Access Compliance Report

Public Rights-of-Way

(Curb Ramps)

Intersection ID: 3655	Main Street: SHENINGTON_PL	Cross Street: TREYBURN_DR	Location: NE
ADA ID: AE5E75FD126C	Ramp Type: Perp	Initial Pass/Fail: Fail	Overall Compliance: No
Severity Score: 12.5			
Codes/Mitigation Info/Possible Solution		Field Measurements/Component Compliance

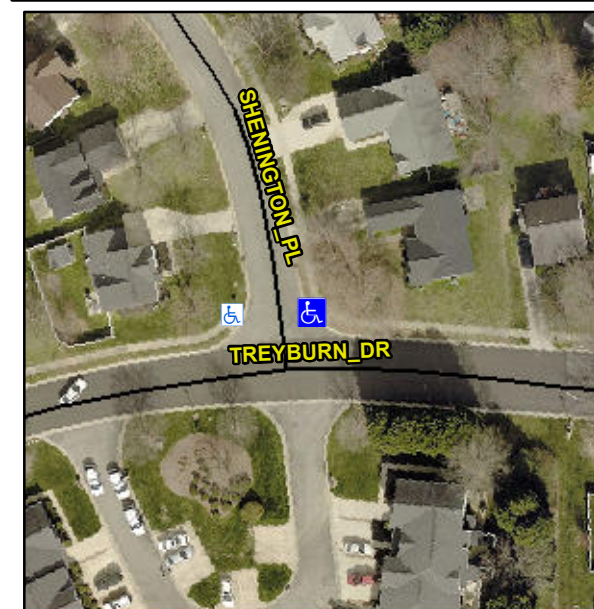
Not Found, R304.2.2

Compliance	Description	Data	Compliance	Description	Data
N/A	Ramp Length (in)	48.0	No	Ramp Slope (%)	9.3
Yes	Ramp Width (in)	48.0	Yes	Ramp XSlope (%)	1.9
N/A	Flare Type LT	N/A	N/A	Flare Type RT	N/A
N/A	Flare Slope LT (%)	N/A	N/A	Flare Slope RT (%)	N/A
N/A	Flare Traversable LT?	N/A	N/A	Flare Traversable RT?	N/A
N/A	Landing Length (in)	N/A	N/A	DWS Provided?	N/A
N/A	Landing Width (in)	N/A	N/A	DWS Contrast?	N/A
N/A	Landing Slope (%)	N/A	N/A	DWS Length (in)	N/A
N/A	Landing X Slope (%)	N/A	N/A	DWS Full Width?	N/A
N/A	Landing Curb? (Y/N)	N/A	N/A	DWS Offset (in)	N/A
N/A	Shared Landing?	N/A			
N/A	Gutter Ponding?	N/A	N/A	Gutter Slope (%)	N/A
N/A	Gutter Lip Ht (in)	N/A	N/A	Gutter X Slope (%)	N/A
N/A	Painted X Walk1?	No	N/A	Painted X Walk2?	N/A
	X Walk 1 Direction	To W		X Walk 2 Direction	N/A
N/A	X Walk 1 Width (in)	N/A	N/A	X Walk 2 Width (in)	N/A
	X Walk 1 Slope (%)	1.2		X Walk 2 Slope (%)	N/A
	X Walk 1 X Slope (%)	3.4		X Walk 2 X Slope (%)	N/A

Remove & Replace Entire Ramp.
